CAIRNGORMS NATIONAL PARK AUTHORITY

Title: APPROVAL OF PROPOSED CNPA RESPONSE TO TRANSPORT SCOTLAND INFORMAL CONSULTATION ON THE A9 DUALLING, PROJECT 8 DALWHINNIE TO CRUBENMORE

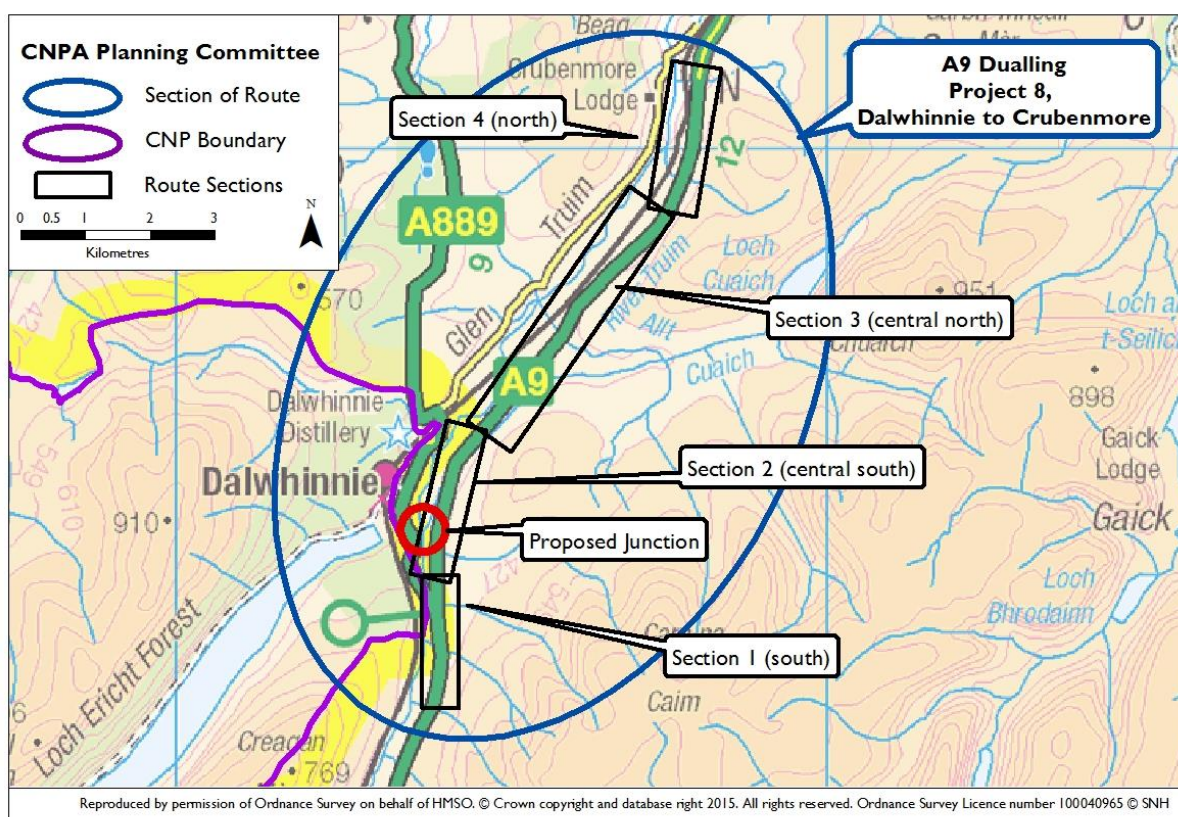
29. Section I has only one option presented which will result in some loss of the existing woodland edge on the east. This is a thin strip of non-native woodland used to manage snow drifting onto the current road. This strip is already subject to an enhancement scheme for a retained track which includes native broadleaved planting along a 5m strip on the eastern edge.
30. For Section 2, the route options to the east of the road are preferred as they will have a lesser impact on the river than the option to the west. There is an overall

preference for route option 2c as this presents a good opportunity for long term local enhancement and strategic enhancements in terms of planting and habitat connectivity.

31. For Section 3, the preferred option is 3b. As for the previous section, this presents the best opportunity for enhancement in the long term.
32. Section 4 has only one option presented which will bring the road very close to the railway necessitating the construction of a retaining wall. This will make the road more visible from the Truim road, NCR7 and Crubenmore Lodge.

35. Junction Option 1 includes an overbridge which will create a horizontal barrier in the landscape. Junction Option 2 includes two roundabouts which will require lighting and therefore impacts upon dark skies. Junction Option 5 will create two 'urban' zones in the landscape. These three options are the least preferred.

36. Junction options 1, 2, 3, and 4 will have a potential impact on NCR7 as a result of the existing Dalwhinnie junction being stopped up and the subsequent configuration of the A889 at this point. Mitigation will be required.

37. The preferred Junction Option is number 3 as it presents the greatest opportunity for enhancement planting and integration into the landscape. Other options will create a more urban effect and have limited scope for ecological and landscape enhancement.

38. It is proposed that CNPA respond with a preference for route options 2c, and 3b and Junction Option 3 provided that mitigation can be achieved for NCR7 and NMU interests.
